**TAKE NOTICE THAT A REGULAR MEETING
OF THE BOARD OF COMMISSIONERS
OF THE CITY OF PHARR, TEXAS
WILL BE HELD AT CITY HALL, COMMISSIONERS' ROOM,
118 S. CAGE BLVD., 2ND FLOOR, PHARR, TEXAS
COMMENCING AT 4:00 PM ON
MONDAY, DECEMBER 1, 2025**

E) Consideration and action, if any, on Change Order Number 2 in the amount of \$49,781.94 and the addition of 15 working days to the construction contract with D. Wilson Construction Company for the Donation Acceptance Program for Fiscal Year 2016. **This item supports IF - Infrastructure.** (ENGINEERING)

**Project: 24-235 Pharr FY16 DAP - Agricultural
Lab, Dock Expansion I & II**
9901 S Cage Blvd
Pharr, Texas 78577

ANSWER

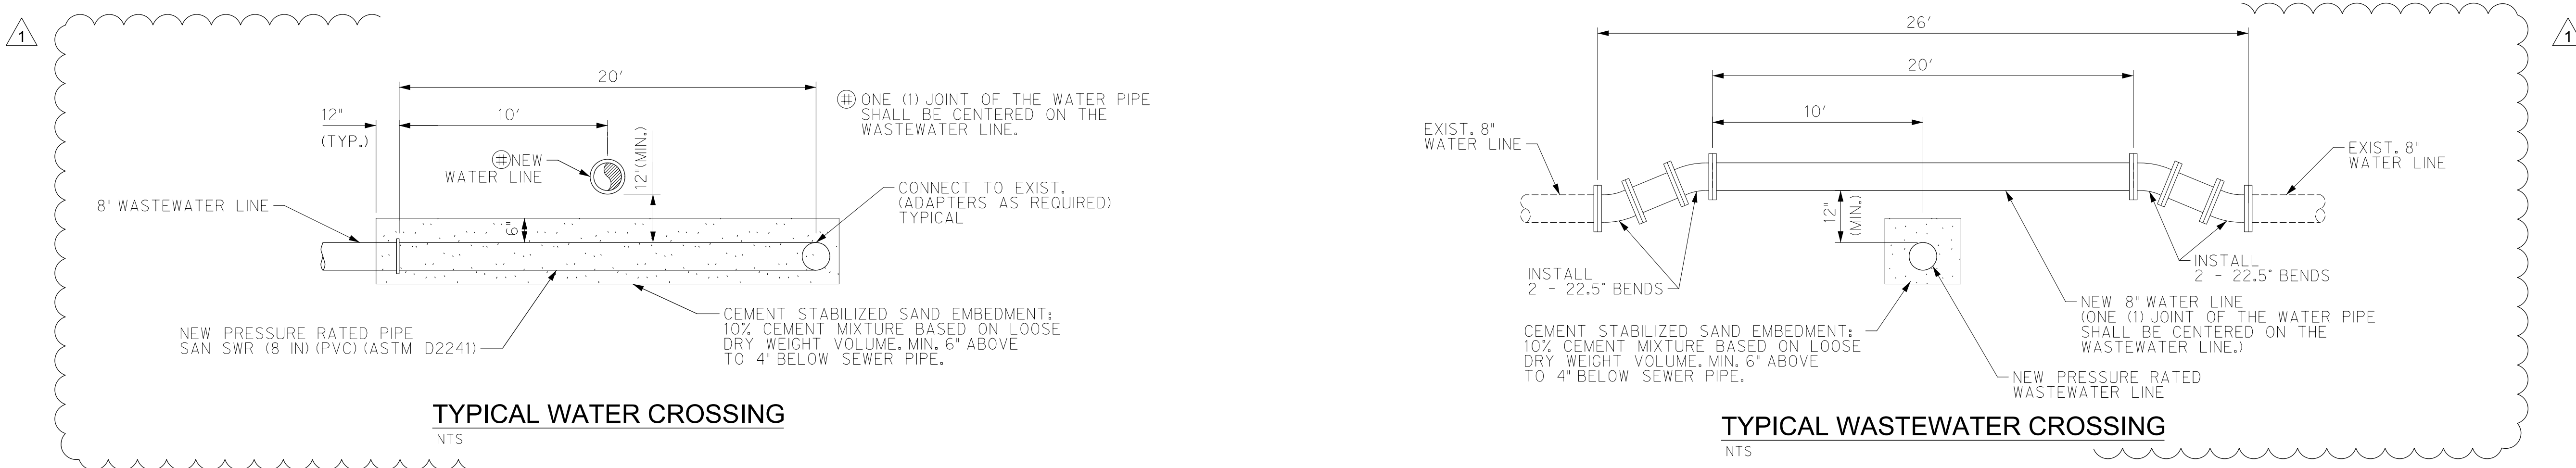
- This sheet has been created in response to RFI #84 – 48" Concrete Manhole.
- This sheet is supplemental to Plan sheet C-401.
- This sheet includes plan, profile, and utility details required to connect the proposed 8-inch sewer line to the existing 8-inch facility sewer line, eliminating the need for the previously proposed sanitary sewer concrete manhole.

Refer to the attached sheet C-401A Utility Plan for information regarding the connection between the proposed 8-inch sewer line and the existing 8-inch facility sewer line.
